**FINDINGS AND RECOMMENDATION
OFFICE OF PLANNING AND ZONING
ANNE ARUNDEL COUNTY, MARYLAND**

CASE NUMBER: 2024-0152-V

REQUEST

The applicant is requesting a variance to allow a dwelling addition with less setbacks than required on property located at 1199 Highview Drive in Annapolis.

LOCATION DRAWING FOR: 1199 HIGHVIEW DRIVE

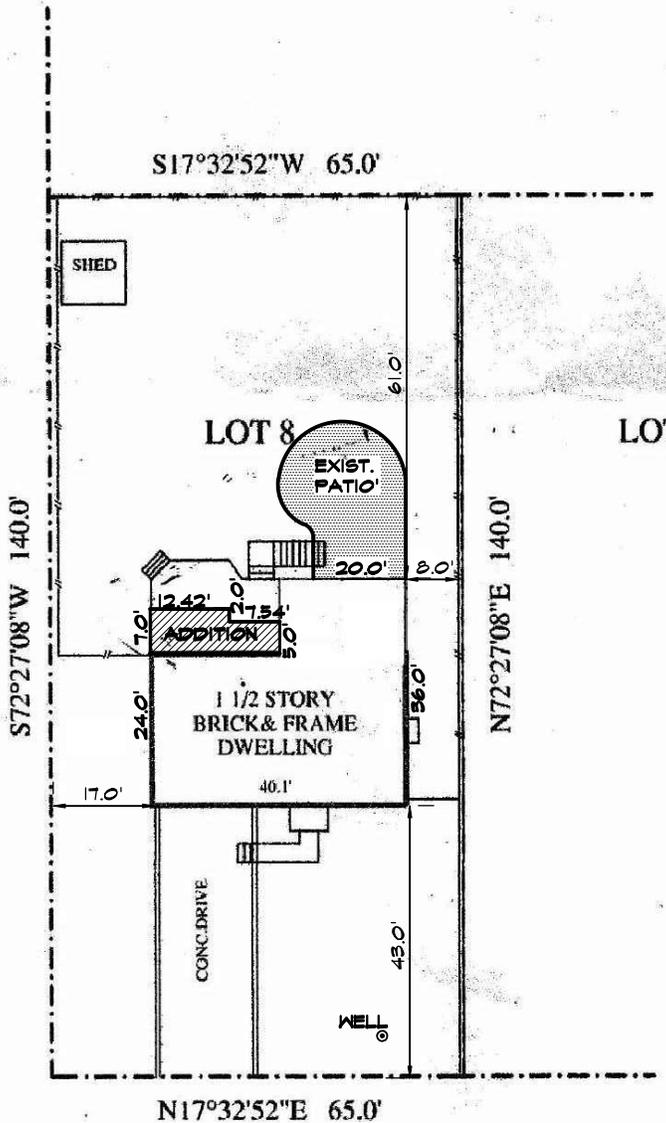
§ 18-4-701 of the Anne Arundel County Code requires a principal structure in the R5 District to be set back 20 feet from the corner side lot line. The proposed addition will be located 17 feet from the corner side lot line, requiring a variance of 3 feet to the corner side setback requirement.

Approval of the variance for setbacks will not alter the essential character of the neighborhood as the proposal is a modest addition to an existing house. The variance will not have an effect on the use or enjoyment of the abutting properties to the east and south as the proposal meets both the interior side and rear setback requirements. Approval of the variance will not be detrimental to the public welfare as the location does not encroach on the street corner of the property allowing a clear sight at the corner and is in-line with the existing dwelling on the corner side behind an existing 6-foot fence.

With regard to the standards by which a variance may be granted as set forth under §18-16-305 of the County Code, the Office of Planning and Zoning recommends **approval** of a variance of three feet to the required twenty-foot corner side lot line setback requirement to allow construction of a dwelling addition located seventeen feet from the corner side lot line.
